Project No. 20056

Client
Nathan Harley (Resource Buildings & Interiors Ltd)
Date
Jan 2022
Scale
1:50 @ A1 / 1:100 @ A3
Project
38 Chester Terrace
NW1 4ND

Drawing Title
Proposed Third Floor Plan

Drawing No. P2003		Rev. B
Drawn PK	Approved LG	Signed TB

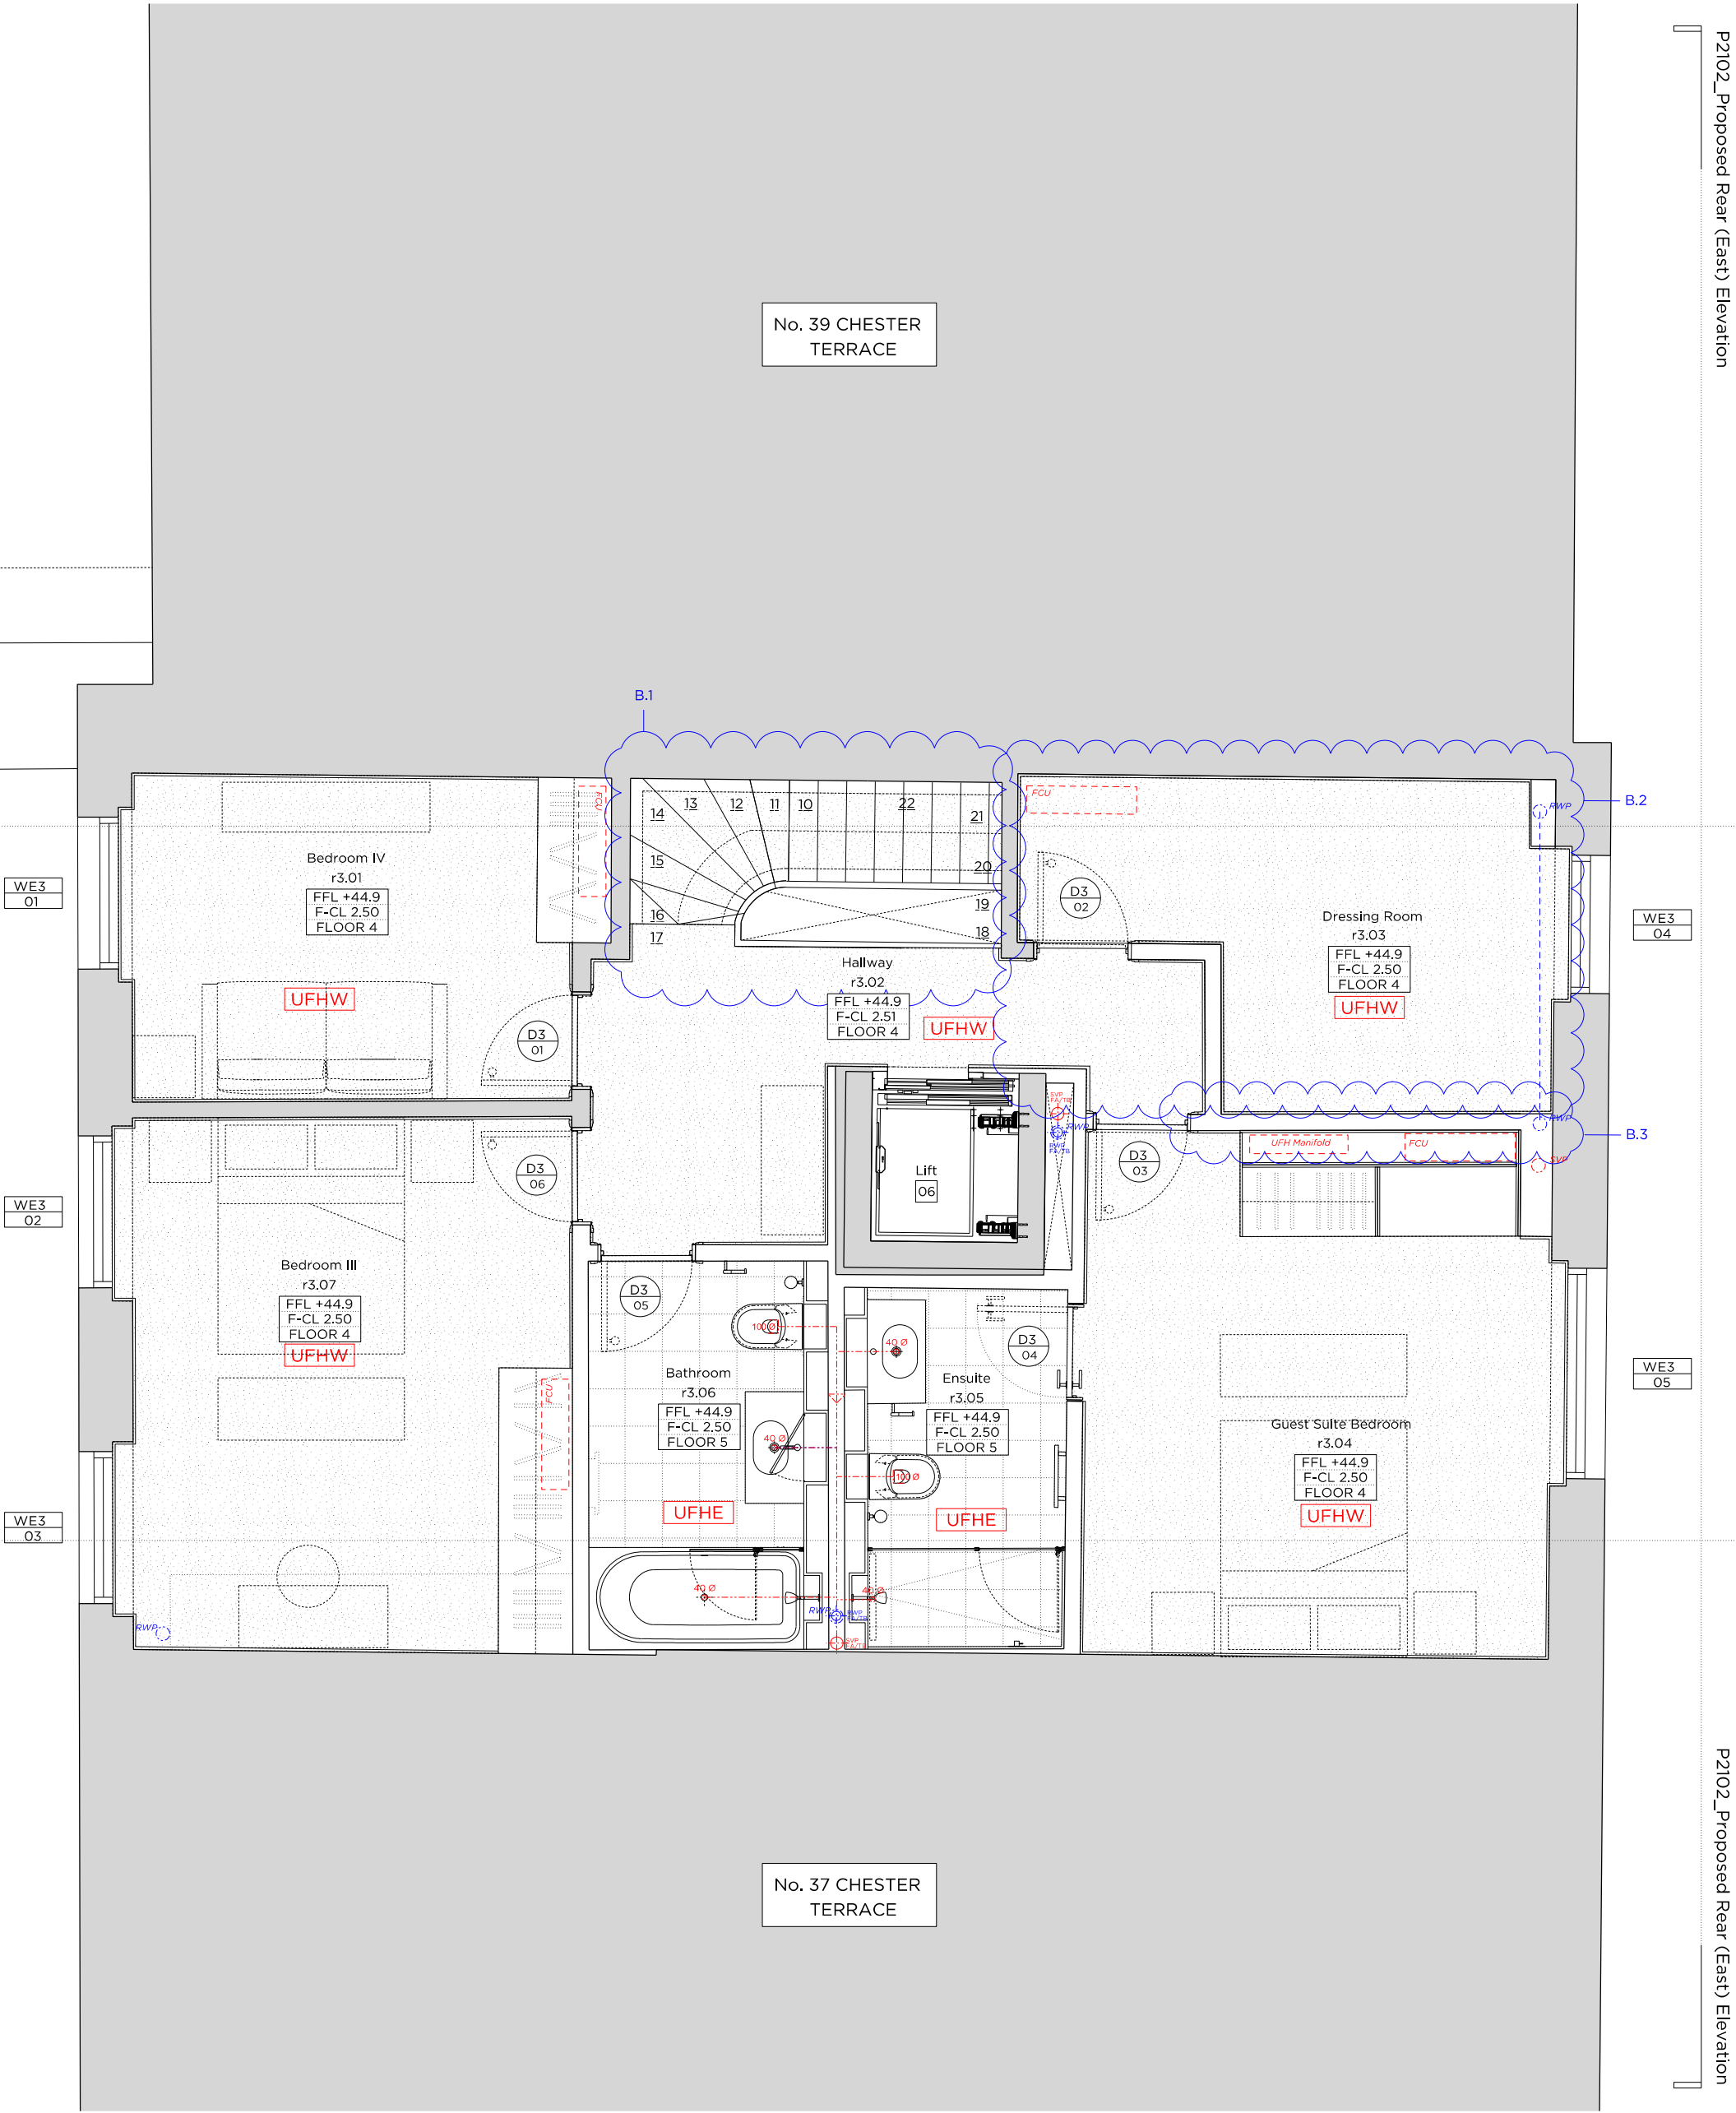
Revision Notes		
Rev. A	06.04.2021	
A.1	Floor finishes in Bedroom IV, Hallway, Dressing Room, Guest Suite Bedroom, Bedroom III amended.	
Rev. B	03.03.2022	
B.1	Stair to roof terrace removed.	
B.2	Joinery removed from dressing room.	
B.3	New wall to Guest Suite Bedroom
